REMARKS

AMENDMENTS TO THE DRAWINGS

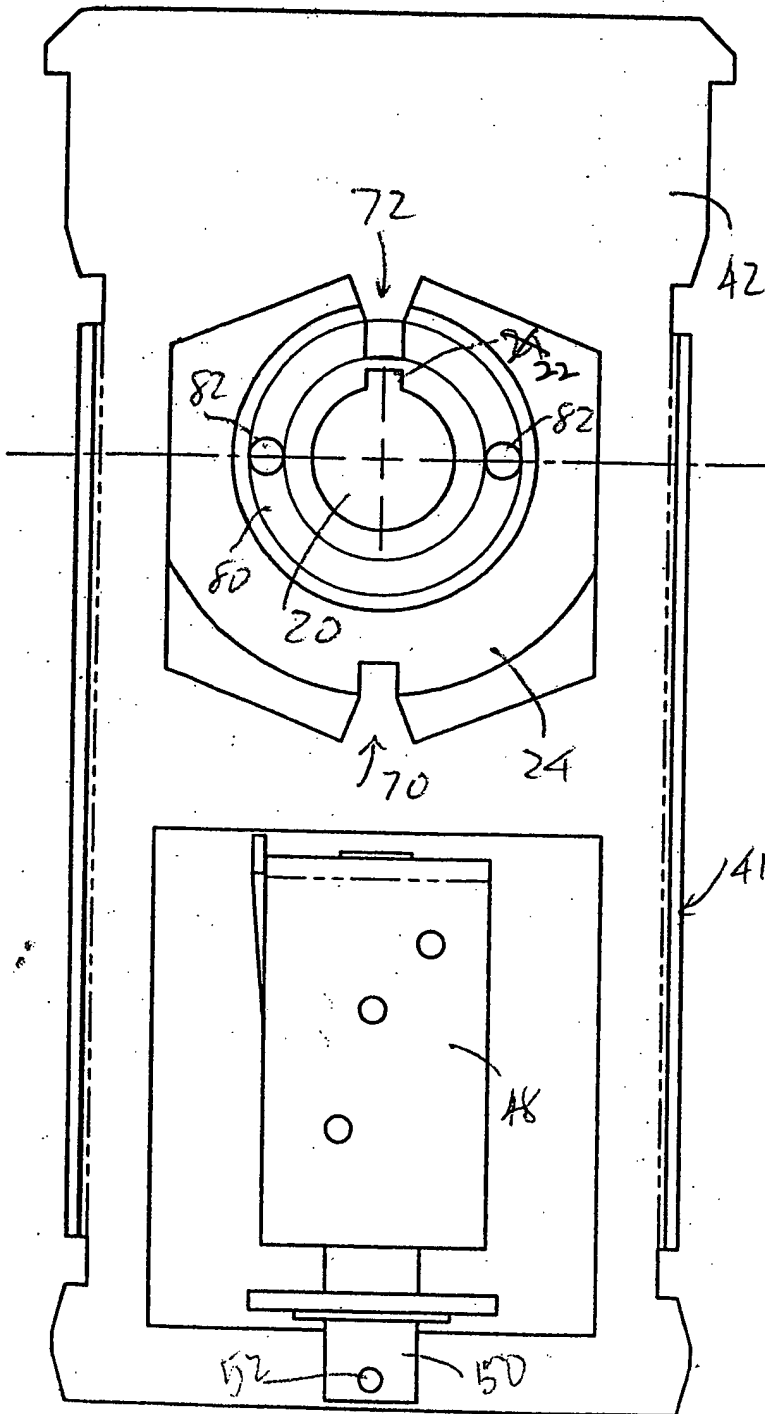
Please amend FIGS. 1 and 2(a)-2(d) as shown in red on the attached marked-up drawings. Applicants have also attached replacement drawings. Specifically, FIG. 1 has been amended to delete reference 46, and FIGS. 2(a)-2(d) have been amended to replace reference number 21 with reference number 22.

FIG 2(b)
UNLOCK ON

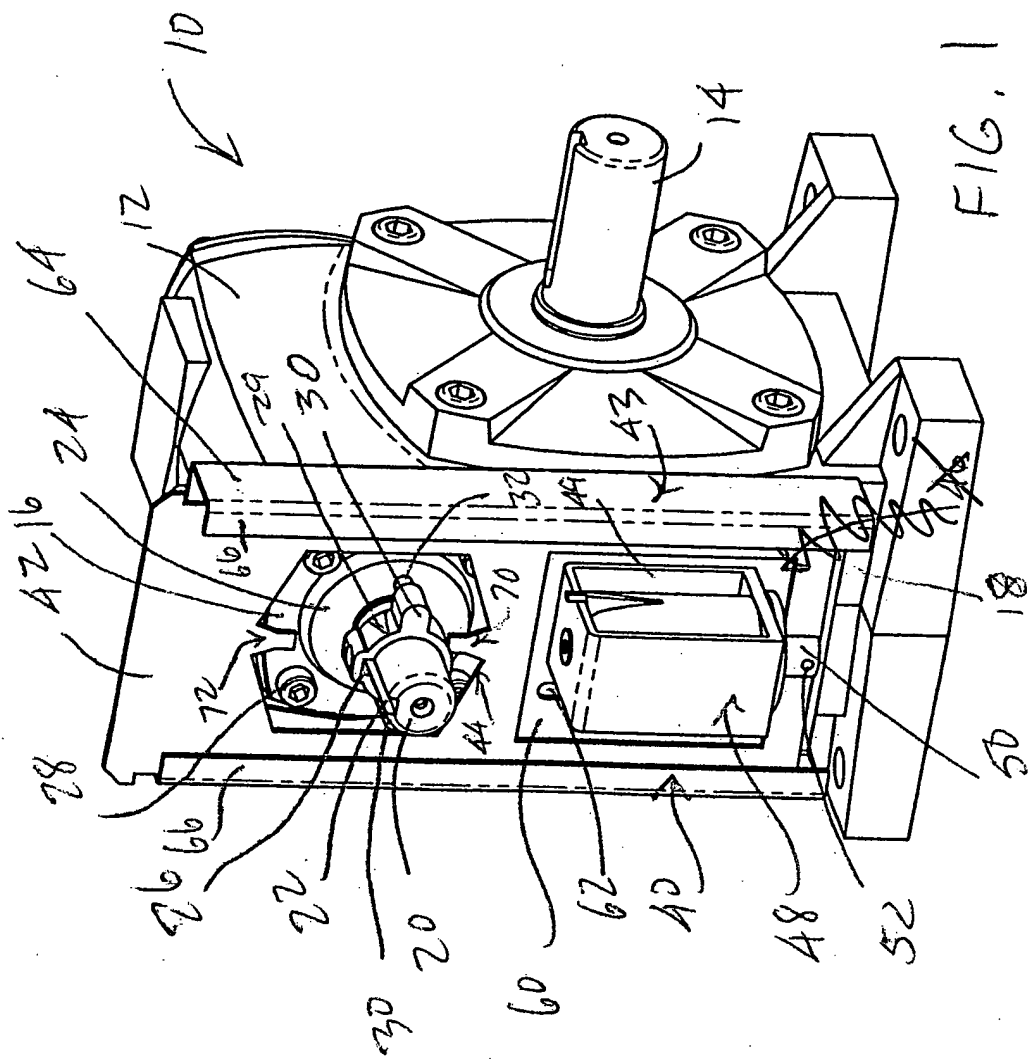
that claims 1, 15, 29, and 43-47 contain limitations reciting that a “slide mounting assembly is moved into a first and a second position, depending if the electrically operated unit is energized or not.” [Office Action, P. 8] The Examiner further alleged that “[a]ccording to Figures 2(a) and 2(b), the element that is displaced is the locking plate 42, not the frame 43.”

Applicants agree that the locking plate may be placed in a first position and in a second position of the slide mounting assembly. Applicants have amended claims 1, 15, 29, and 43-47 to recite that the locking plate, not the slide mounting assembly, may be placed in the first position and in the second position of the slide mounting assembly. Accordingly, Applicants respectfully submit that claims 1, 15, 29, and 43-47 meet the enablement requirement. Claims 2-12, 16-26, and 30-40 depend from claims 1, 15, and 29, respectively, and therefore also meet the enablement requirement. Thus, Applicants submit that the Examiner’s rejection of claims 1-12, 15-26, 29-40, and 43-47 under 35 U.S.C. §112, ¶1 has been traversed, and should be withdrawn.
